DRB Project Number: PR-2025-020144 Hearing Date: **12-10-2025**

Project: 907 Montano Rd NW Agenda Item No: 3

#### **PA-2025-00374 – SKETCH**

***Purpose of Plat***

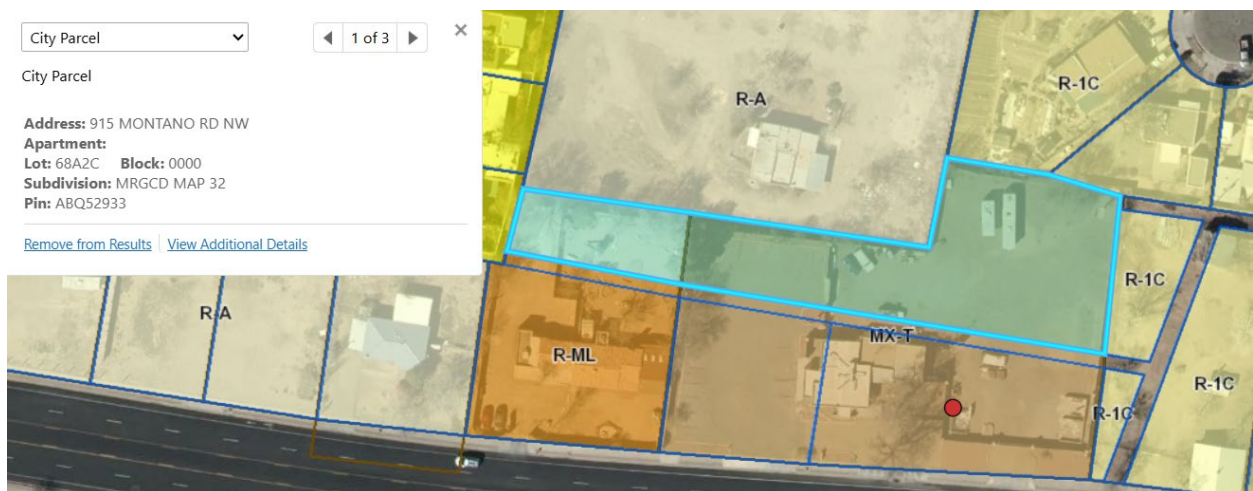
**Correct the Purpose of Plat to depict the legal lots that are being consolidated to create the Plat.**

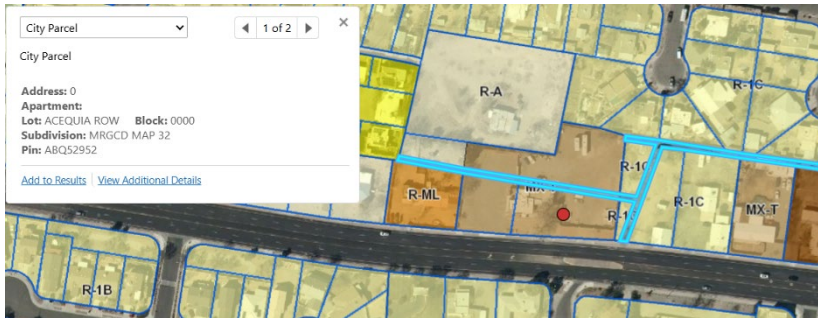
**Lot 68A2C shows as a whole City lot in AGIS. Proof of deeded boundary line required.**

- Per 6-6(K)(2)(c) If the subdivision will result in a lot line that does not coincide with a zone district boundary (i.e., create a "floating zone line"), the applicant shall obtain a Zoning Map Amendment - EPC or Zoning Map Amendment - City Council, as applicable, **to establish zone boundaries that coincide with the lot line before a final plat can be approved.**

The Zoning Map Amendment must be approved first and out of the 15-day appeal period before the approval of the proposed plat. The application can run concurrently but the plat actions must meet the new zone district that is chosen during the zoning map amendment.
